Subject: WATER LEAK AROUND THE OVERHEAD CONSOLE	Bulletin No.: 09-034/23
	Last Issued : 10/09/2023

2024 CX-90 (with panorama sunroof) with VINS lower than JM3KK*****121941 (produced before July 12, 2023)

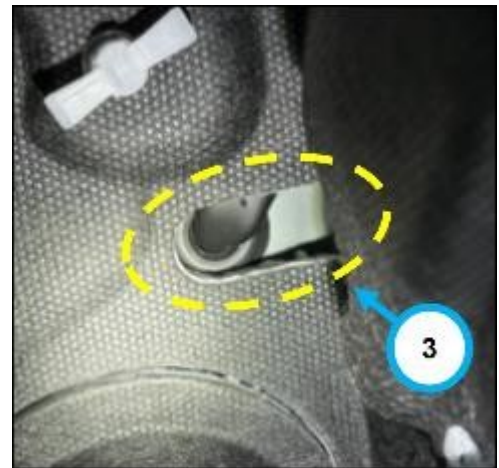
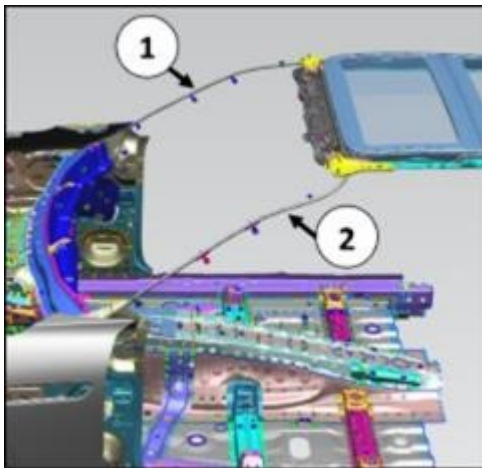
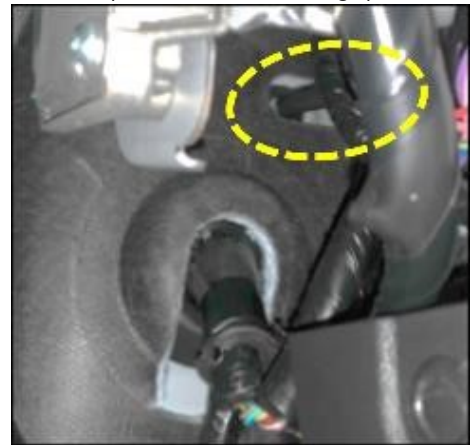
Some customers may complain about water leaks around the overhead console. This may be caused by the front drain hoses (1 and 2) for the panorama sunroof being trapped by the front dash panel insulator (3) and not being able to provide the correct water drainage.

The location of the trapped point for left hand side.
(R.H.D. vehicle image)

The location of the trapped point for right hand side.
(R.H.D. vehicle image)

The zoomed up location of the trapped point for right hand side.
(R.H.D. vehicle image)

To eliminate this concern, the front drain hoses placement has been changed so that the hose fits in the insulator notch. Customers having this concern should have their vehicle repaired using the following repair procedure.

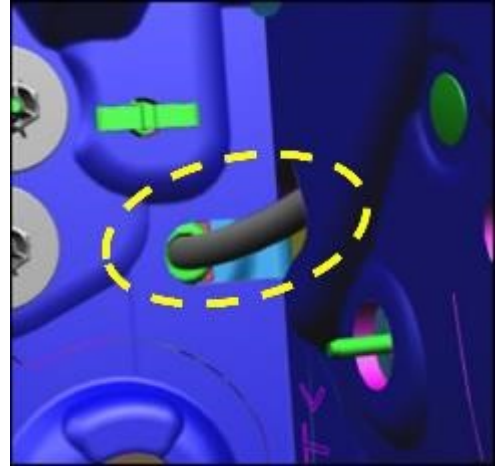
1. Verify the customer concern.
2. Use a flashlight and locate the notch and hose on the corners of the firewall inside the vehicle.
 - If the hoses are trapped, proceed to the next step.
 - If the hoses are not trapped, no further work is required.

Before correction

After correction
